MODELS: 40, 45

## **IGNITION MODULE, FLYWHEEL, CRANKSHAFT**

On the models 40 and 45, we will introduce big changes. See the table below and illustrations on the next page.

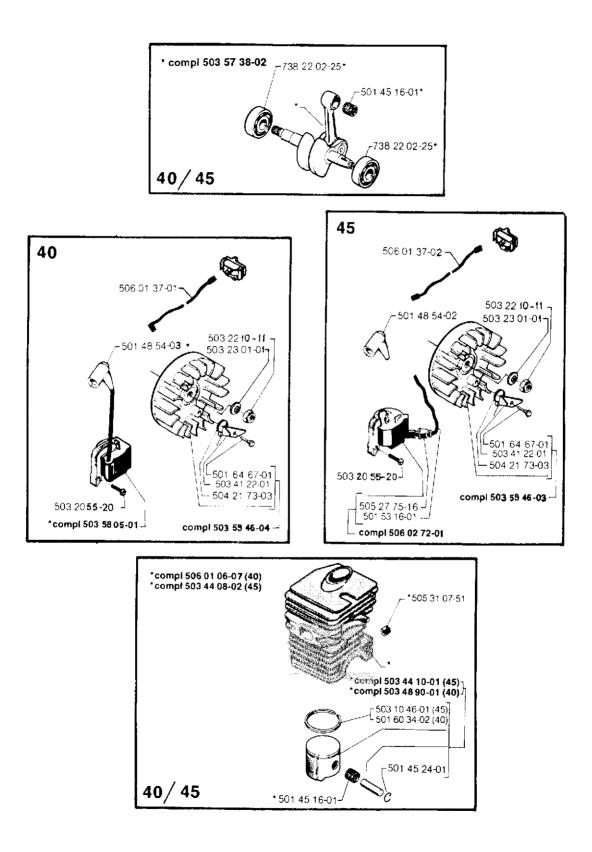
- 1 = Replaced parts remain as spare parts
- 2 = When the Phelon module is introduced, a new cylinder is also introduced. The cooling fins are made somewhat smaller behind the ignition module mounting and compared to the previous cylinder. The Phelon-module only fits on cylinder Ref. No. 506 01 06-07.

The changes include a replacement of the key in the flywheel with a cast-in key.

This means that we are going to have two different ignition systems, which require two different ignition modules and two different flywheels. The flywheels Ref. No. 503 59 46-03 and Ref. No. 503 59 46-04 are identified by the cast-in Ref. No. on the inner side.

We have already introduced these changes on the model 40 from serial number9101116. The changes introduction on the model 45, will be reported in a separate service bulletin.
